## BUILDING DESIGN

BPDA/BCDC Approved Design

## **BPDA/BCDC** Approvals process

**401 PARK REIMAGINED**

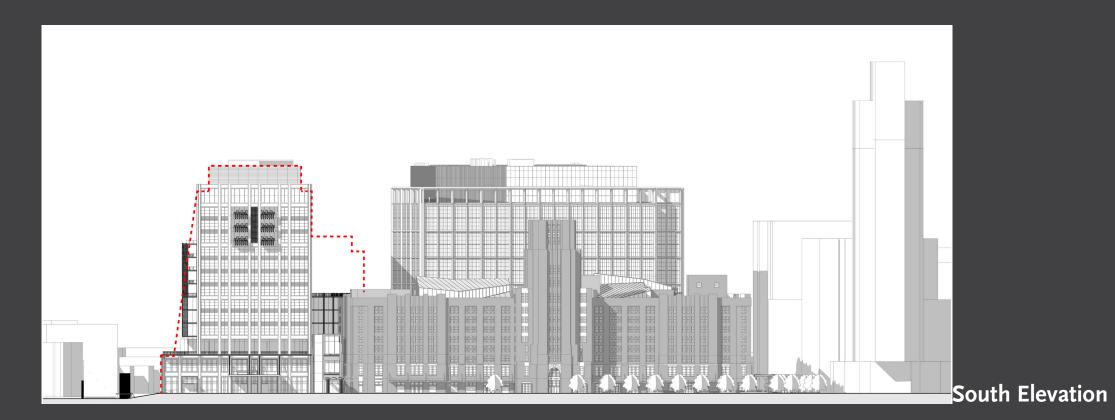
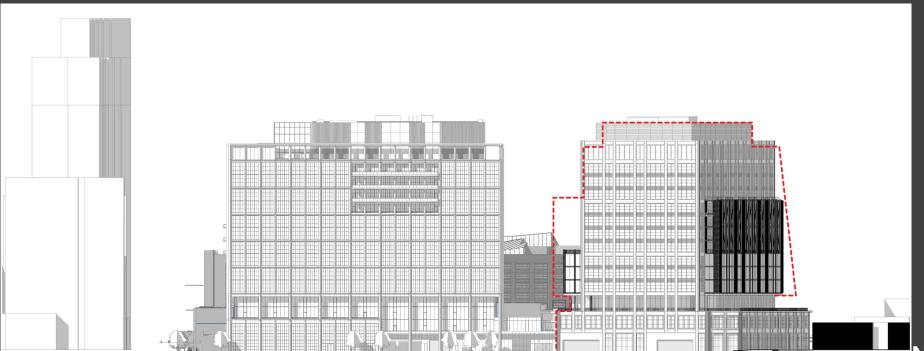
THE ARCHITECURAL DESIGN OF THE NEW CONSTRUCTION WAS REFINED BASED ON COMMENTS RECEIVED DURING THE BPDA/BCDC PROCESSES. REFINEMENTS INCLUDE ELIMINATING THE CURVED ELEMENT ON THE PARK DRIVE ELEVATION AND CREATING A MORE CONSISTENT ARCHITECTURAL LANGUAGE FOR THE NEW ARCHITECTURE OF PHASE 2 AND 3. THESE REFINEMENTS ARE ALL INTENDED TO ENSURE THAT THE HISTORIC SEARS BUILDING REMAINS AT THE FOREFRONT OF THE VIEW PERSPECTIVE ALONG PARK DRIVE AND THAT THE NEW ARCHITECTURE DOES NOT DRAW ATTENTION AWAY FROM THE HISTORIC BUILDING.
